- 3. Queen Aleta Subdivision
KPB File 2023-015**

KPB File No.	2023-015
Plat Committee Meeting:	February 27, 2023
Applicant / Owner:	David R. and Queen Aleta Parker of Sterling, Alaska
Surveyor:	John Segesser / Segesser Surveys
General Location:	Adkins Road, Line Avenue, Sterling

STAFF REPORT

Queen Aleta Subdivision

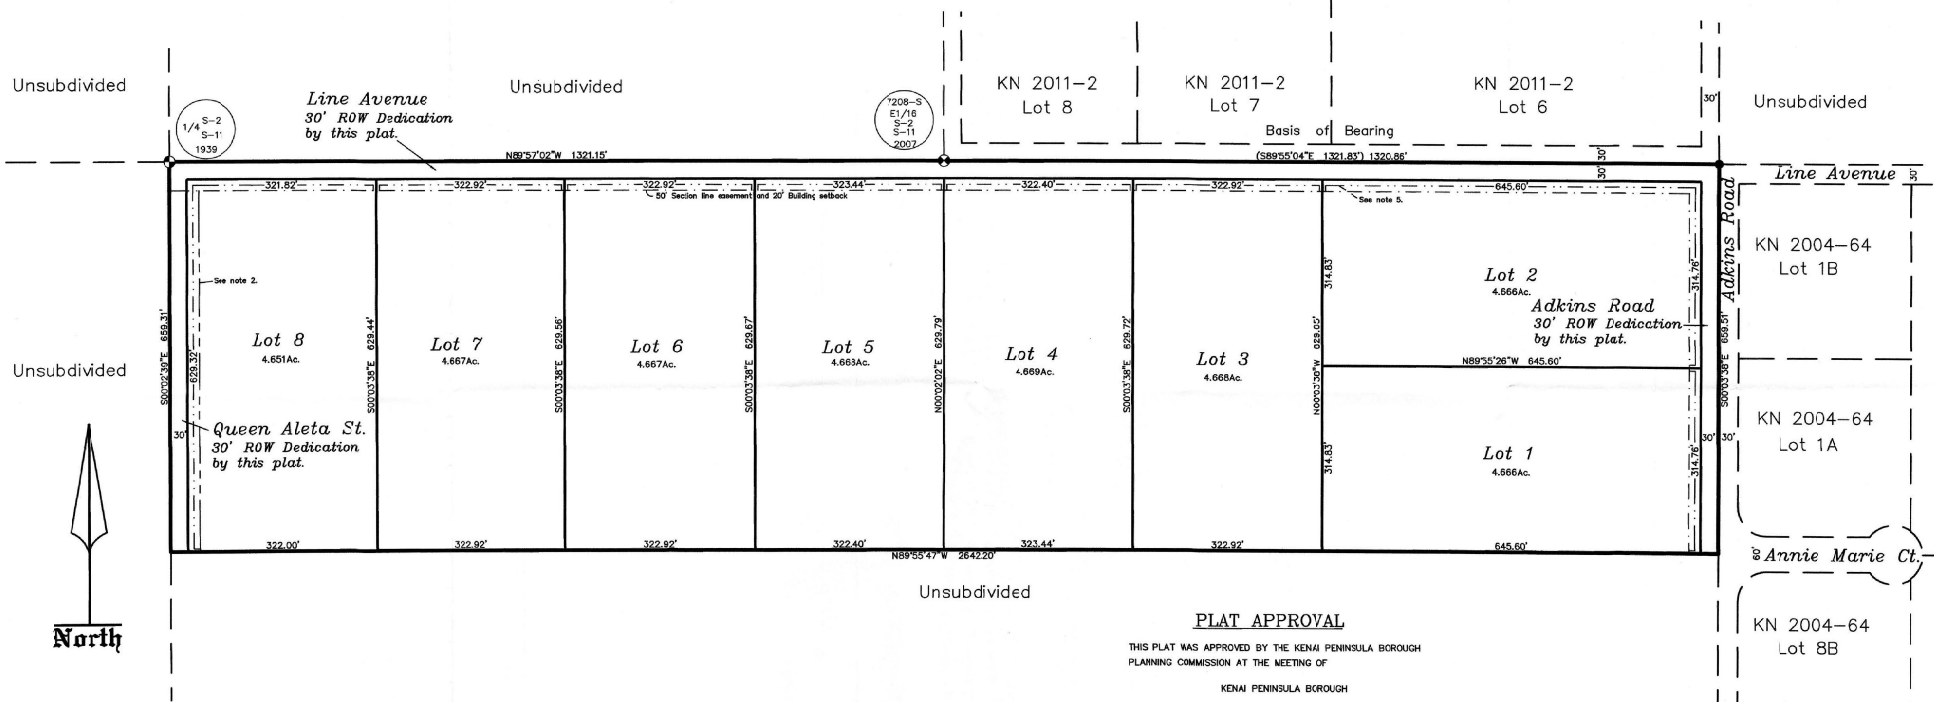
A new dedication is proposed along the western boundary. This is a half dedication with the other half expected from the neighboring property if ever subdivided. The name proposed for the street is Queen Aleta Street. About half a mile to the north is Aleta Avenue off Adkins Road. Due to the proximity and similar name ***staff recommends the street name be shortened to Queen Street.***

Along the western portion of the subdivision there does appear to be some steep slopes present. Some of these steep slopes appear to be within the proposed right-of-way dedications. **Staff recommends centerline profiles and cross-sections be provided for Line Avenue and Queen Aleta Street to determine if additional right-of-way widths or easements are needed. Show the centerline of Line Avenue on the plat drawing.**

Site Investigation: There are no low wet areas within the subdivision boundary. There does appear to be some steep terrain present within the northwest area of the subdivision. Staff is recommending centerline profiles for the proposed dedications due to the terrain. **Staff recommends any steep slopes greater than 20 percent be indicated on the final plat as it may impact development or driveway access.**

- C. The location, width, and name of existing or platted streets and public ways, railroad rights-of-way, and other important features such as section lines or political subdivisions or municipal corporation boundaries abutting the subdivision;
Staff recommendation: *Some road depiction and section line easements will need to be updated before final based on preliminary approved plats in the area. The width of Line Avenue east of Adkins Road needs to be updated as does the eastern half of Adkins Road. Provide a label and width for Coronet Street. If the dedication to the north has not been recorded prior to final, show the section line easement, and show the section line easement along Adkins Road south of the subdivision.*

- D. A vicinity map, drawn to scale showing location of proposed subdivision, north arrow if different from plat orientation, township and range, section lines, roads, political boundaries, and prominent natural and manmade features, such as shorelines or streams;
Staff recommendation: *Update the spelling on the lake label.*

- F. The location, width and name of existing and platted streets and public ways, railroad rights-of-way, easements, and travel ways existing and proposed, within the subdivision;
Staff recommendation: *Name of Queen Aleta Street may need to be revised.*

- M. Approximate locations of slopes over 20 percent in grade and if contours are shown, the areas of the contours that exceed 20 percent grade shall be clearly labeled as such;
Staff recommendation: *Contours were not shown. Reminder that failure to present such information may delay the scheduling of an item for a meeting as the application will be viewed as incomplete. Northwest corner has steep areas that need to be identified.*

- 20.30.160. Streets-Name requirements. Streets shall be named to conform to KPB Chapter 14.10
Staff recommendation: *Aleta Avenue is located to the north of this subdivision. It is advised to remove Aleta from the name and staff recommends “Queen Street”.*

Correct plate note 4 by adding the reference to KPB Code 14.06.

As plat note 6 states that all wastewater systems need to comply with DEC requirements, plat note 3 is not required.

- "Subject to a right-of-way granted to Alaska Pipeline Company per BLM Serial No. A-051647 that is 25 feet from centerline as stated within State of Alaska Patent 7657."
- Subject to a right-of-way permit granted to Homer Electric Association, Inc. by ADL 51477 for an electrical distribution line, 20 feet on centerline as stated within State of Alaska Patent 7657."
